Access Compliance Report

Public Rights-of-Way

(Curb Ramps)

Intersection ID: 16387	Main Street: BILLINGSLEY_RD	Cross Street: CONSERVANCY_LN	Location: NE
ADA ID: 78F812D8BD95	Ramp Type: PerpDiag	Initial Pass/Fail: Fail	Overall Compliance: No
		Severity Score: 22.5

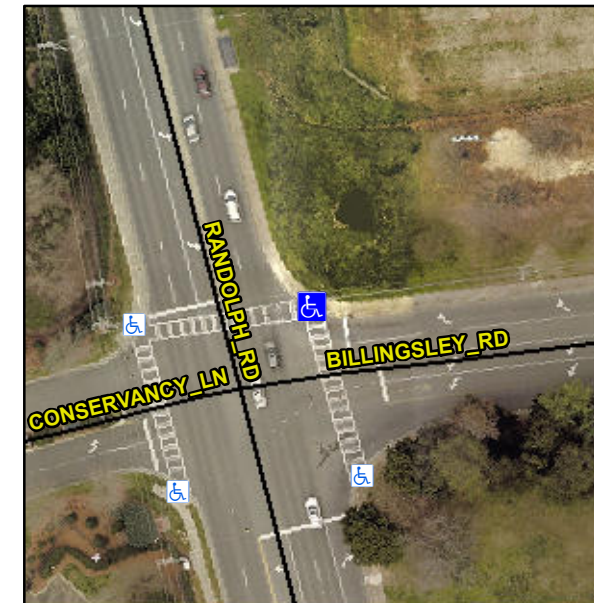
R304.5.1, R304.2.2, R304.5.3

Compliance	Description	Data	Compliance	Description	Data
N/A	Ramp Length (in)	72.0	No	Ramp Slope (%)	10.6
No	Ramp Width (in)	43.0	No	Ramp XSlope (%)	4.7
N/A	Flare Type LT	N/A	N/A	Flare Type RT	N/A
N/A	Flare Slope LT (%)	N/A	N/A	Flare Slope RT (%)	N/A
N/A	Flare Traversable LT?	N/A	N/A	Flare Traversable RT?	N/A
N/A	Landing Length (in)	N/A	N/A	DWS Provided?	N/A
N/A	Landing Width (in)	N/A	N/A	DWS Contrast?	N/A
N/A	Landing Slope (%)	N/A	N/A	DWS Length (in)	N/A
N/A	Landing X Slope (%)	N/A	N/A	DWS Full Width?	N/A
N/A	Landing Curb? (Y/N)	N/A	N/A	DWS Offset (in)	N/A
N/A	Shared Landing?	N/A			
N/A	Gutter Ponding?	N/A	N/A	Gutter Slope (%)	N/A
N/A	Gutter Lip Ht (in)	N/A	N/A	Gutter X Slope (%)	N/A
N/A	Painted X Walk1?	Yes	N/A	Painted X Walk2?	Yes
	X Walk 1 Direction	To W		X Walk 2 Direction	To S
N/A	X Walk 1 Width (in)	110.0	N/A	X Walk 2 Width (in)	104.0
	X Walk 1 Slope (%)	2.8		X Walk 2 Slope (%)	3.0
	X Walk 1 X Slope (%)	3.7		X Walk 2 X Slope (%)	2.0

Remove & Replace Curb Ramp With Two New Directional Ramps or Equivalent.
